# Customer Service Bulletin

### Greensmaster<sup>®</sup> 3200-D

**Subject: NEUTRAL RETURN SPRING PIN REWORK**

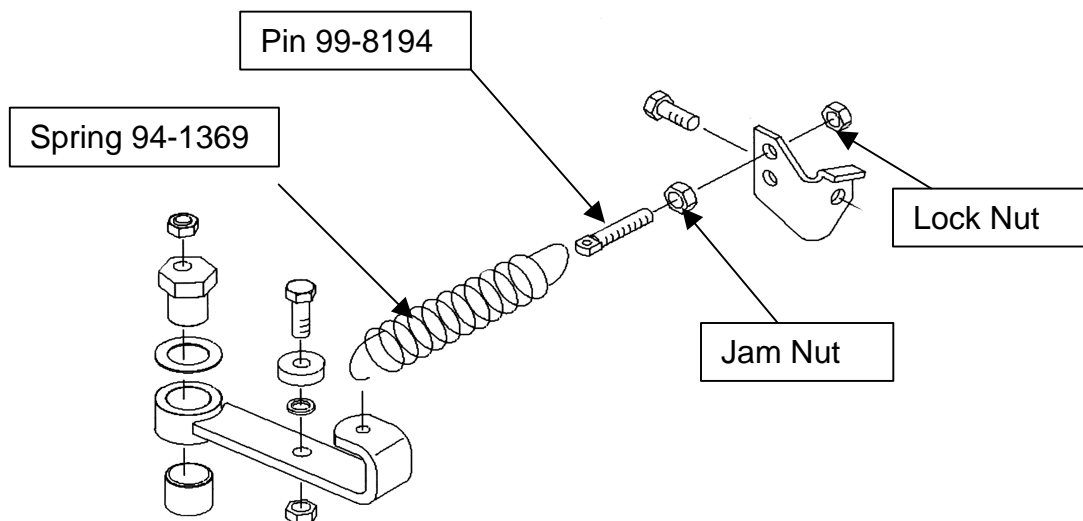
The Pin that connects the neutral Spring to the frame, may wear through. If the pin wears through, the transmission will not automatically return to neutral and could result in personal injury, equipment damage or turf damage.

Replace the parts (Spring and Pin) identified below. These parts are located on the top of the transmission. Best access for the Locknut is with a deep well socket wrench and extension inserted over the top surface of the muffler. Allow muffler to cool.

1. Replace Spring (94-1369) and Pin (99-8194). Position jam nut at similar position on new pin so spring tension does not change.
2. Test unit to ensure neutral return mechanism works correctly. If neutral adjustment is required, follow printed instructions found in appropriate Toro operators manual.
